**CITY OF CHESTERFIELD
PLANNING COMMISSION MEETING
MONDAY - FEBRUARY 12, 2007
7:00 PM**

Planning Commission Staff Report

DATE: January 19, 2007

RE: Conway Point Office Building – January 12, 2007 Submittal
PZ 16-2006, R3 to PC

PRELIMINARY DEVELOPMENT PLAN

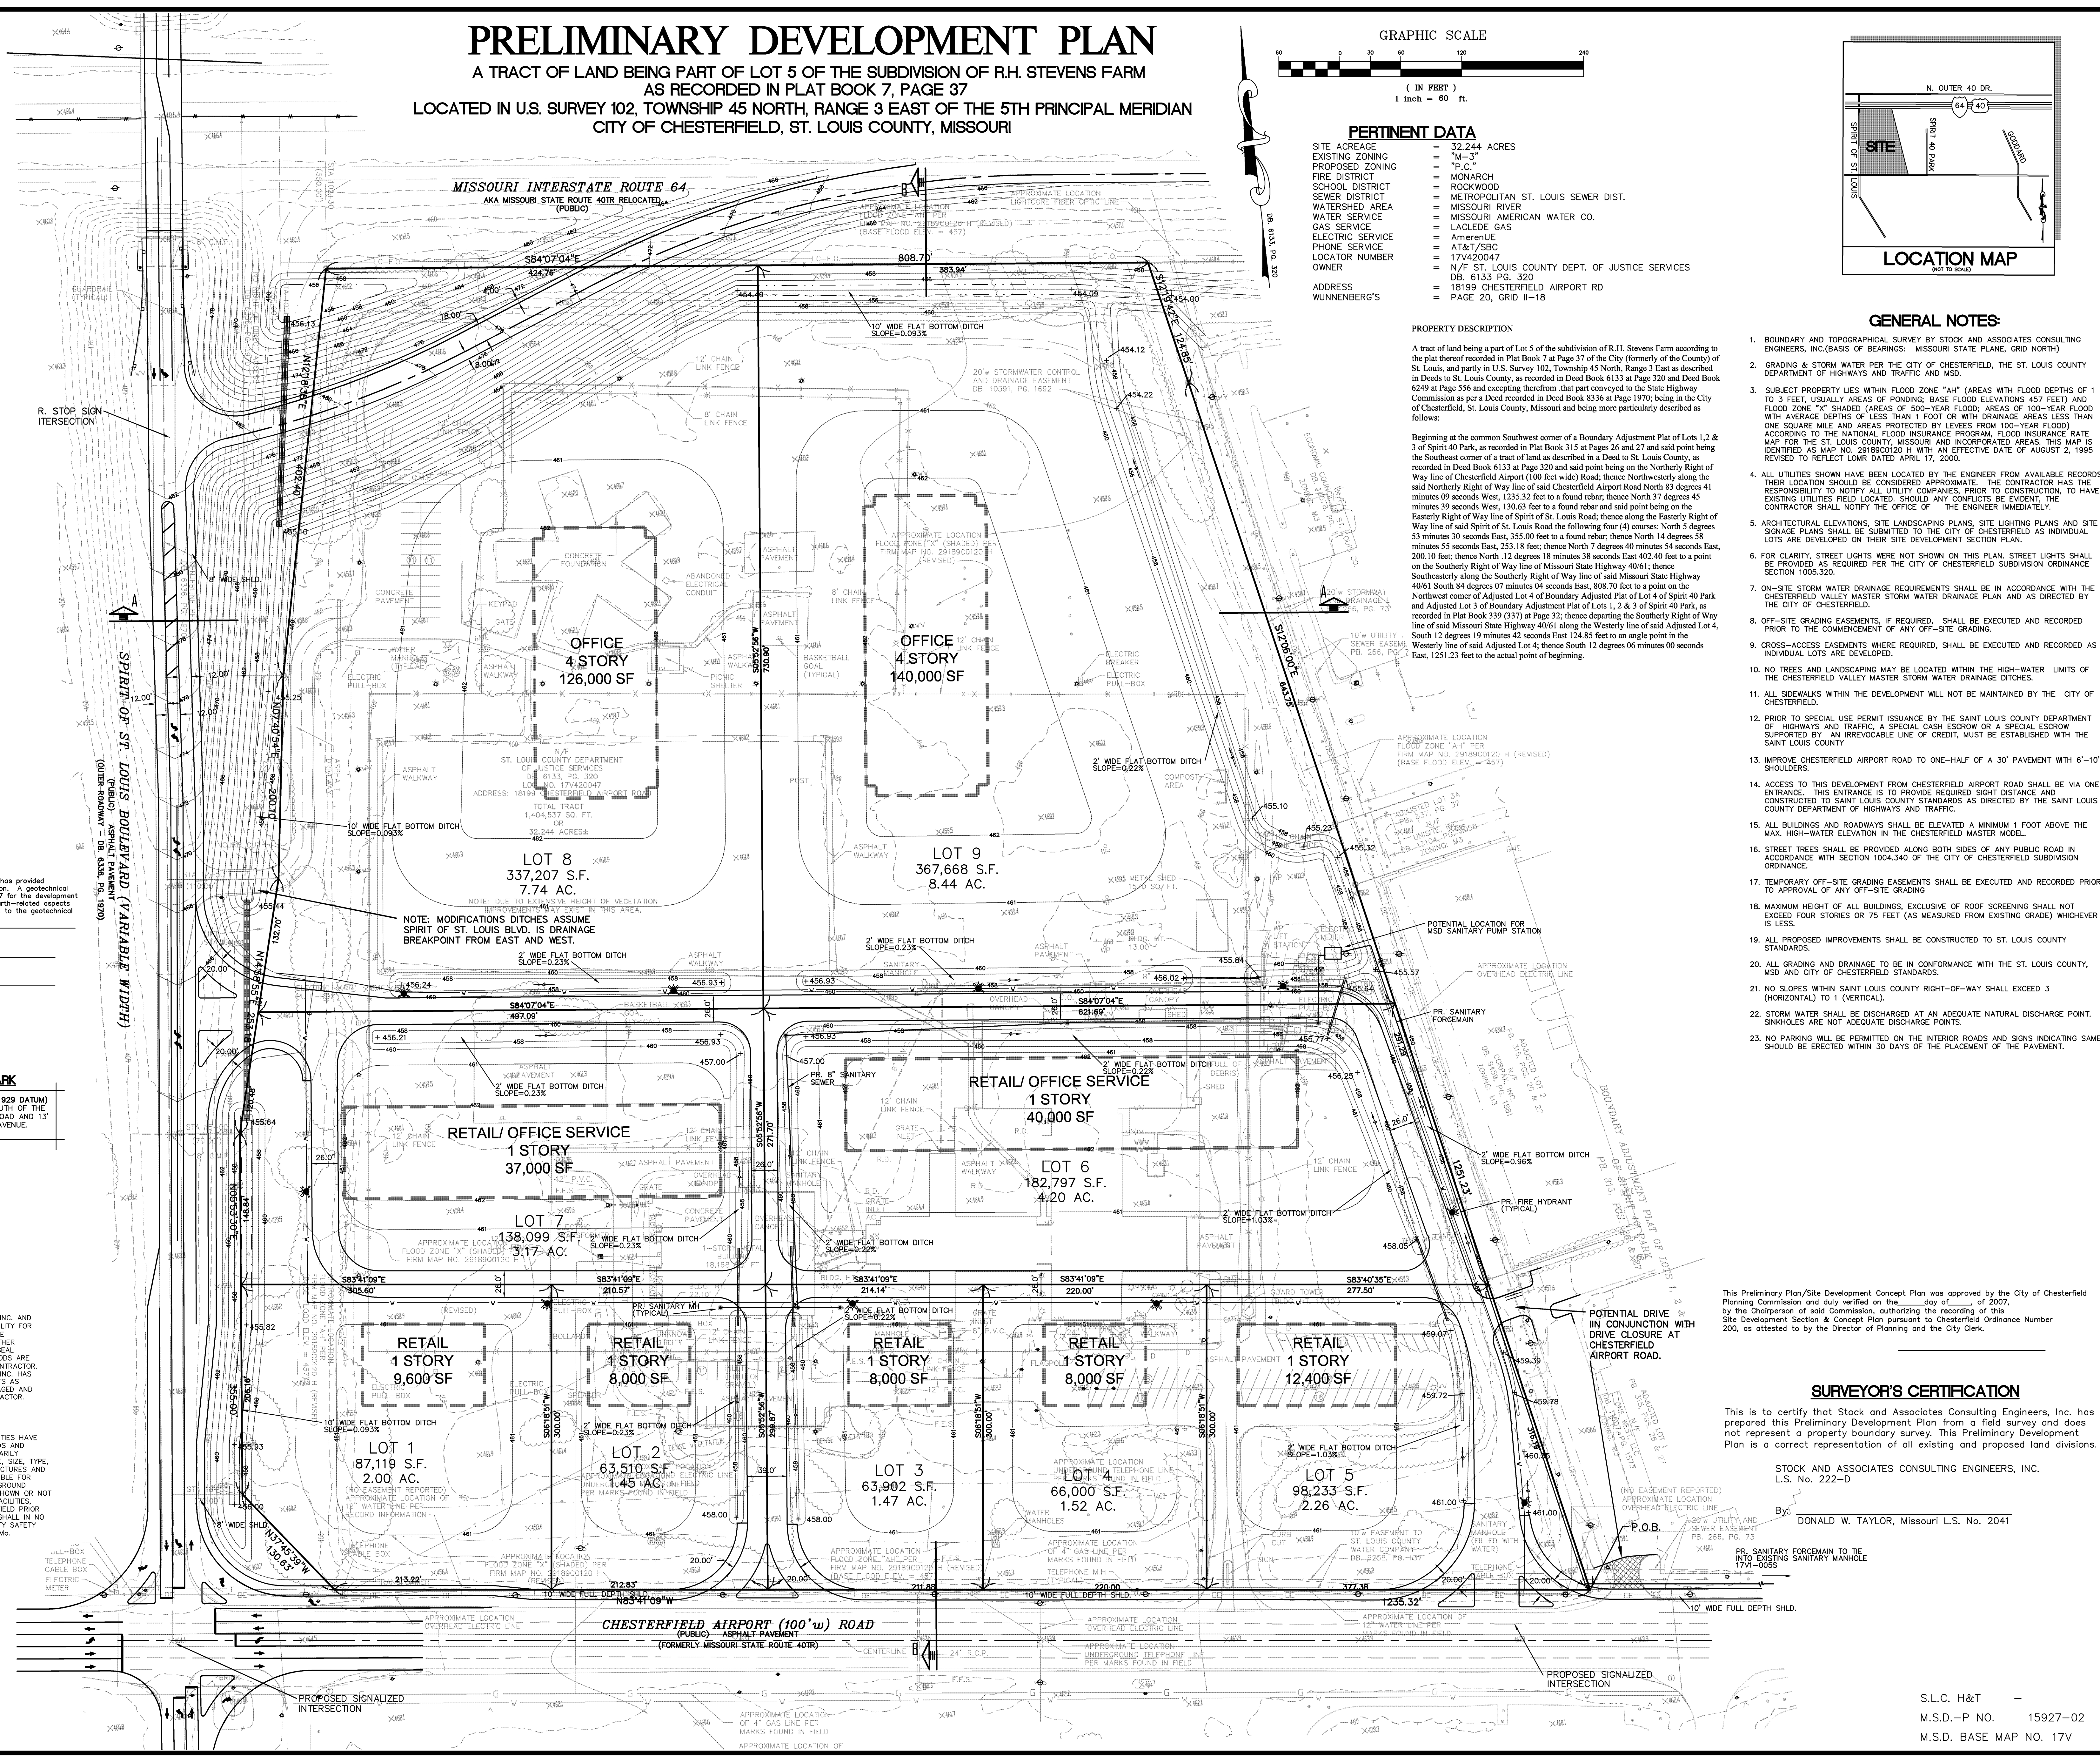
5. Will a sign package be requested for this development?
6. The plan shows, on the west side of the site, a proposed driveway off of the internal street connecting to Spirit of St. Louis Boulevard. The location of this entrance does not meet the minimum, standards set forth in the Access Management Ordinance.

8. St. Louis County has indicated and the Department of Public Works concurs, that while they cannot require it at this time, anything that can be done to improve the alignment of the proposed eastern drive with Crown Industrial Court would be advantageous.
9. The stormwater facilities depicted on the plan do not comply with the Chesterfield Valley Master Stormwater Plan. The Department of Public Works is willing to have the Master Plan consultant review the proposed improvements if the developer makes such a request. The developer would be responsible for all costs related to consideration of the alternate proposal.

Designed: SWQ
Drawn: SLH
Checked: EAS
Date: 09/14/06
Project Number: 98218.3
Sheet Number: 1 of 3

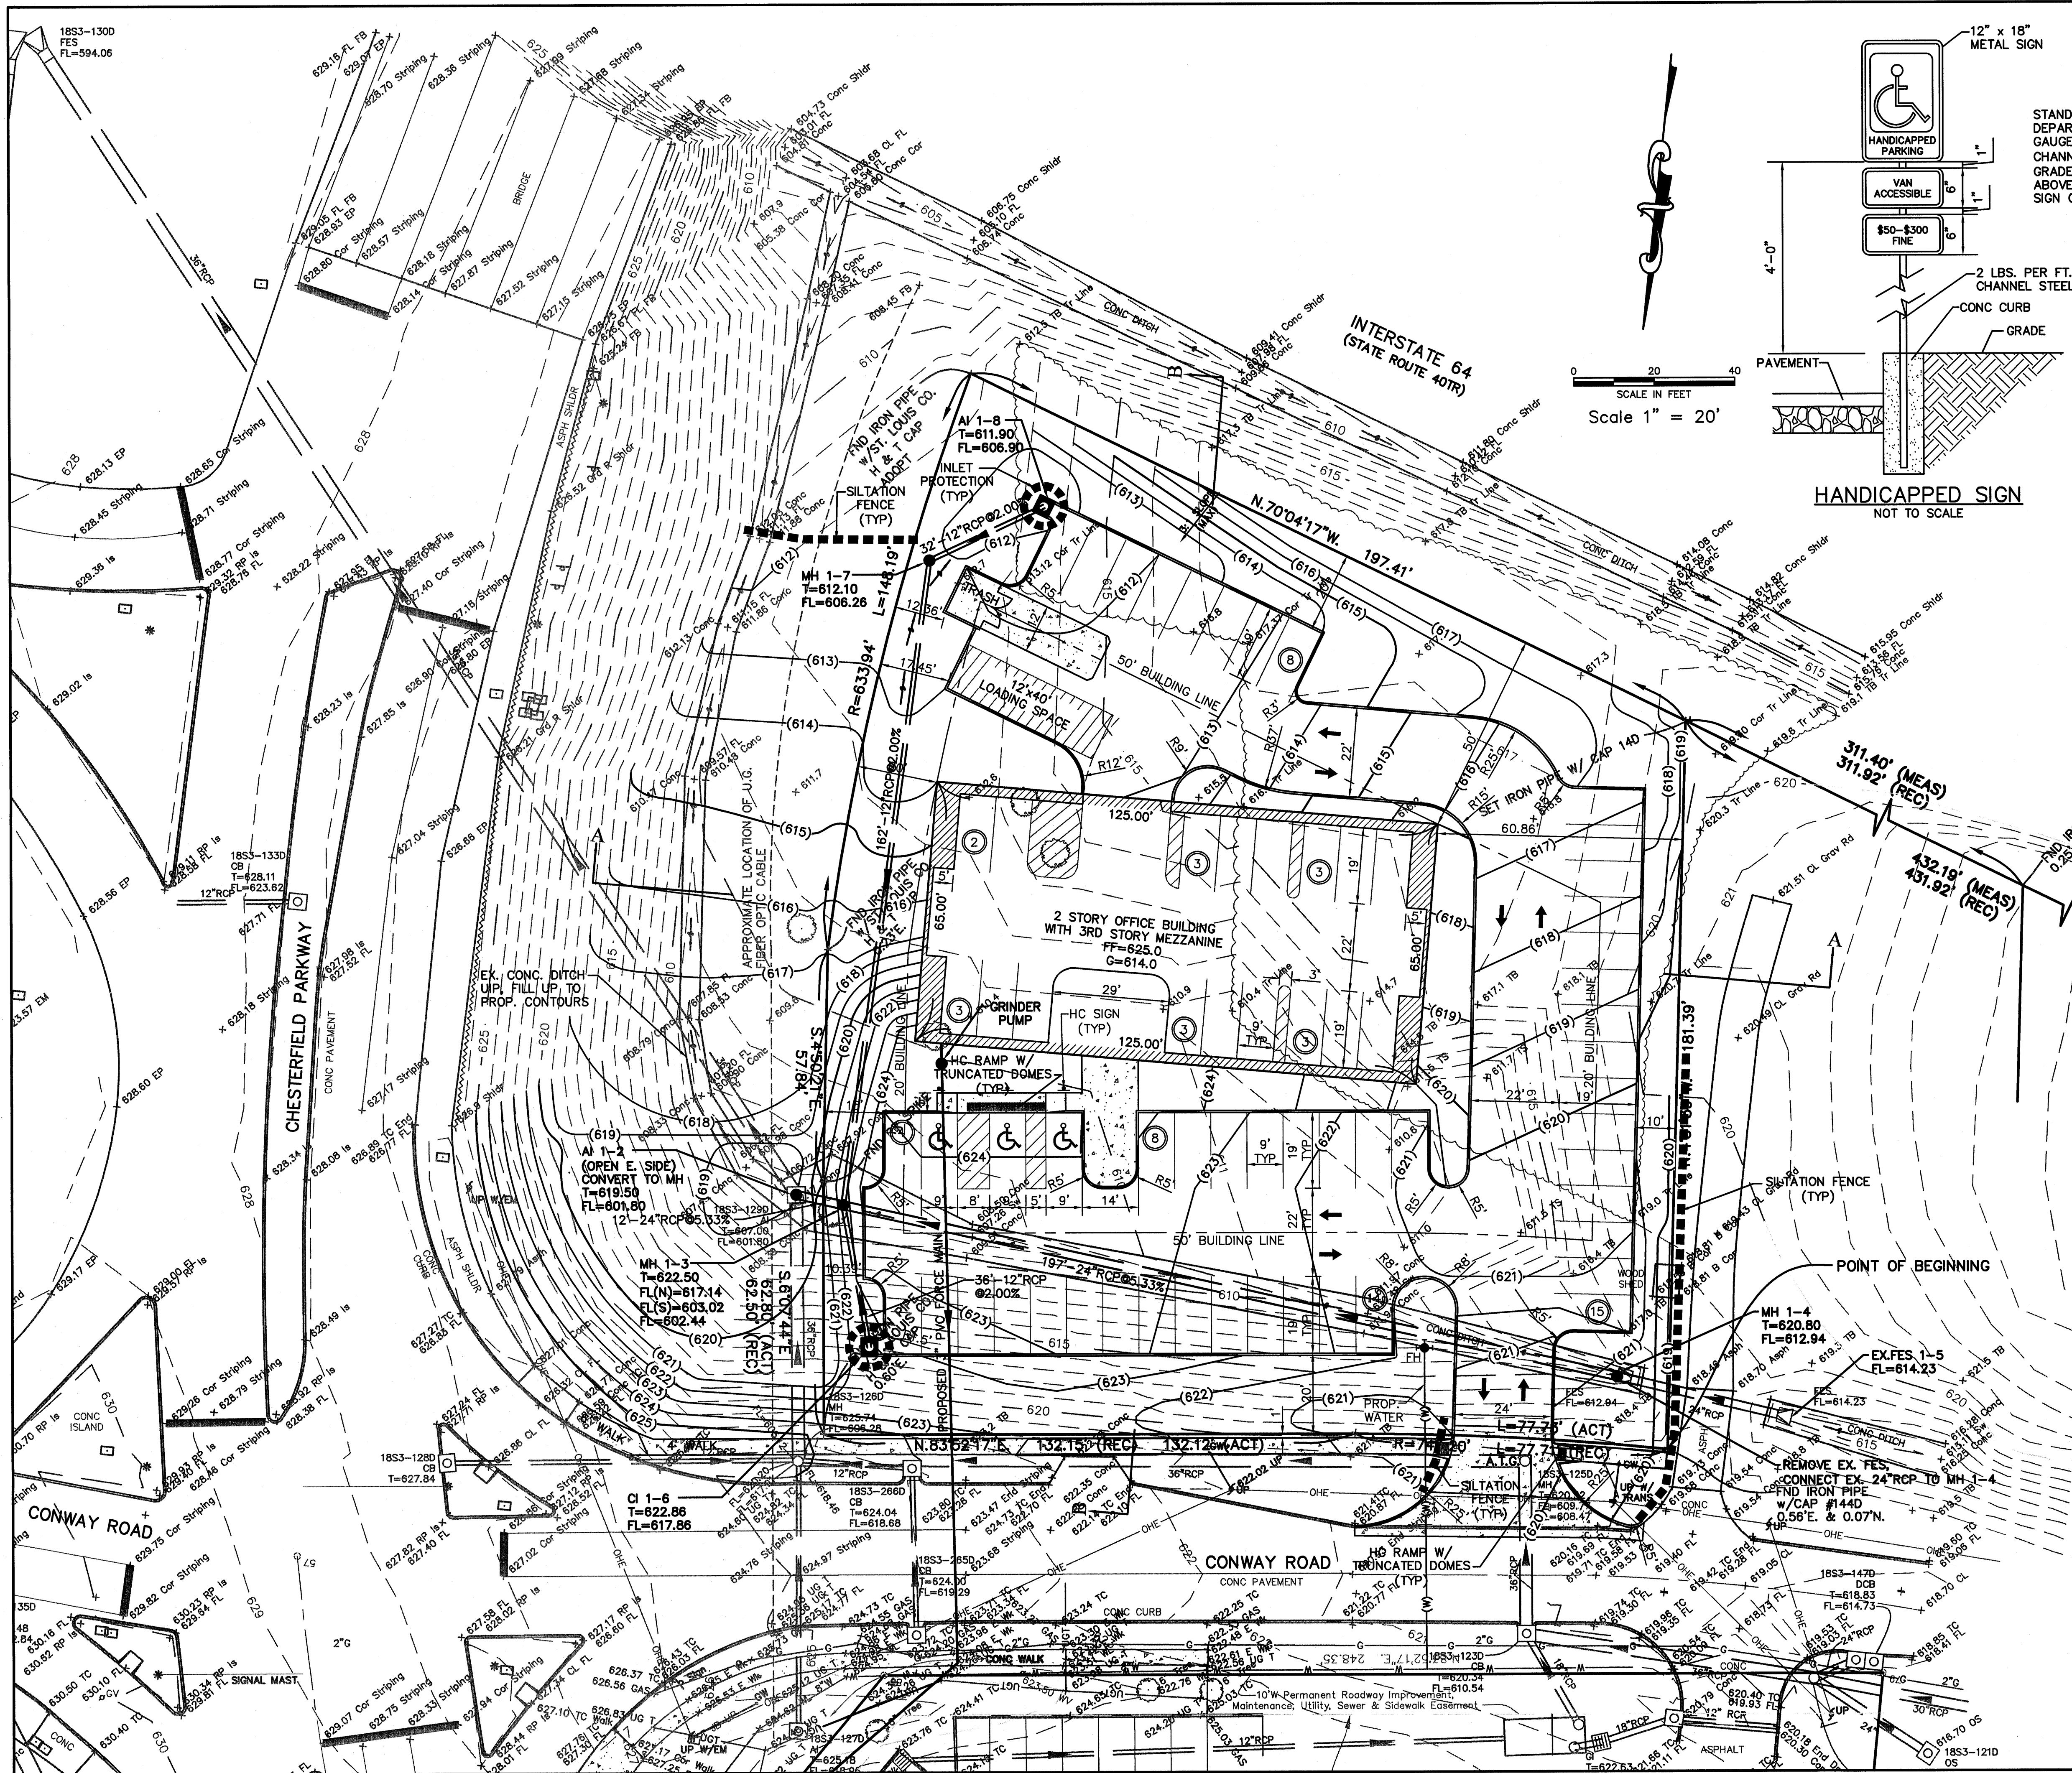
5. On sheet 1 of 3, portions of the sanitary force main appear to be located outside the existing utility easement. Either the force main alignment will require revision or additional easements obtained. This issue need not be addressed at this time, but will be reviewed in greater detail during review of the Improvement Plans.
